SNPP REF:	PPSSNH-738
COUNCIL	WILLOUGHBY CITY COUNCIL
DA NO:	DAM-2025/105 (Original DA-2024/13)
ADDRESS:	100 EDINBURGH ROAD, CASTLECRAG
APPROVED DEVELOPMENT:	SNPP - Nominated Integrated Development - Construction of a new mixed use building containing retail uses including a supermarket, residential units, basement car parking, with associated landscaping and Stratum subdivision. The application is identified as nominated integrated development requiring approval from Water NSW pursuant to s90 the Water Management Act 2000.
PROPOSED MODIFICATION:	Various modifications to basement levels including expansion in basement size at Basement Level 3, new Basement Level 4, increased basement floor to ceiling heights, modification to storage spaces, structural column changes, inclusion of EV charging facilities, modified stormwater, modification of conditions 1, relocated lift locations.
RECOMMENDATION:	REFUSAL

1. PURPOSE OF REPORT

The purpose of this report is to seek determination by Sydney North Planning Panel (SNPP) of Modification Application DAM-2025/105 relating to various changes that essentially increases the approved floorplate of Basement Level 3 and introduces a new Basement Le

Image 4: Approved ground level plan superimposed over Basement Level 4 to show the intrusion (in red) of the proposed retail lifts into the approved supermarket space.

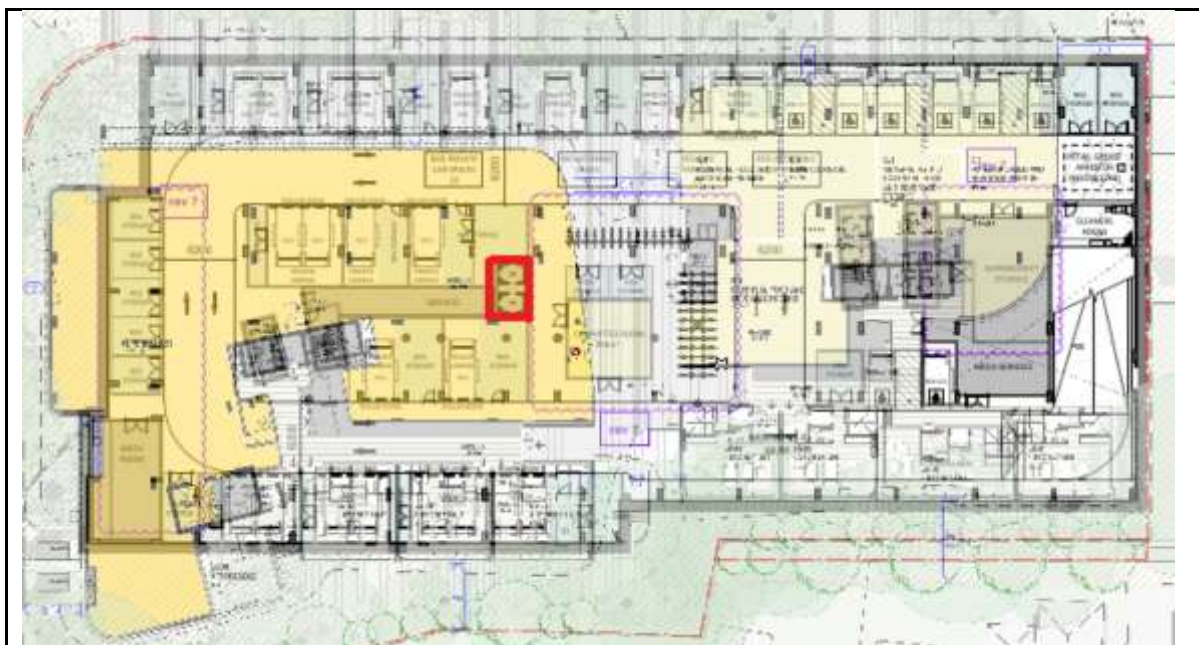
However, the basement plans are incompatible with the approved floor plates above. The proposed lift cores dissect the approved floor plates of the approved residential and non-residential floor plates. The modification application does not demonstrate in what way the upper floor plates accommodate the modified locations for the lifts.

For reference, the assessment planner interpolates that the upper floor plates are disrupted by the relocated lifts as follows:

Image 3: Approved Level 2 superimposed over Basement Level 4 to show the intrusion (in yellow) of the proposed residential lifts into unit 202 and 209. The lifts will similarly impact units 102 and 110.
